APPENDIX B
Final
SECTION 4(F) EVALUATION

Golden Gate Bridge Physical Suicide Deterrent System Project
City and County of San Francisco and County of Marin, California

Project 2006-B-17
04-MRN-101-GGHT
Federal Project #: STPL-6003(030)

FIGURE 3
SECTION 4(f) RESOURCES: MARIN APPROACH

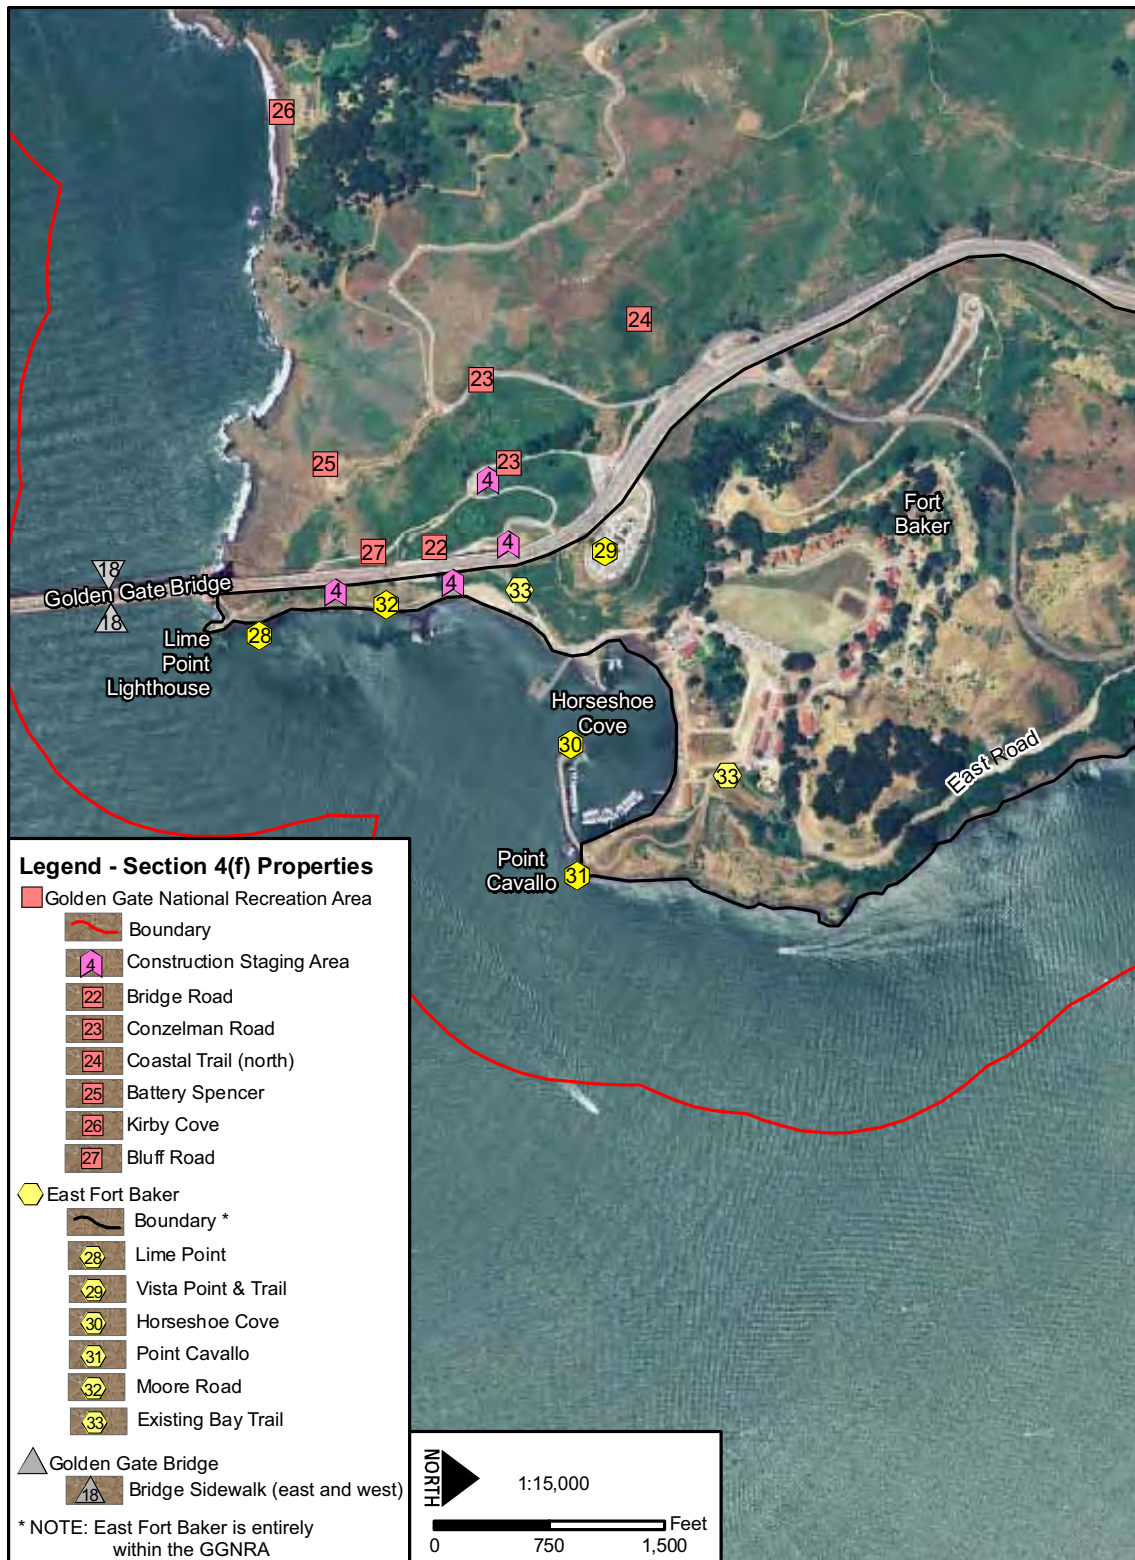
- 10. Figure 2.1-2 Correct GGNRA offshore boundary. Show Fort Baker as part of GGNRA. 1 j
- 11. Show Construction Staging Areas (item 4) in a separate color and symbol. 1 k

The United States Department of Interior, GGNRA requests a correction be made to Figure 2.1-2 to show the legislative boundary of the GGNRA and to show all of East Fort Baker as part of the GGNRA. The commenter also requested that construction staging areas shown on this figure have a distinct color and symbol.

Figure 2.1-2 has been updated accordingly; see page 2-4 and Appendix B, page 11, of the Final EIR/EA.
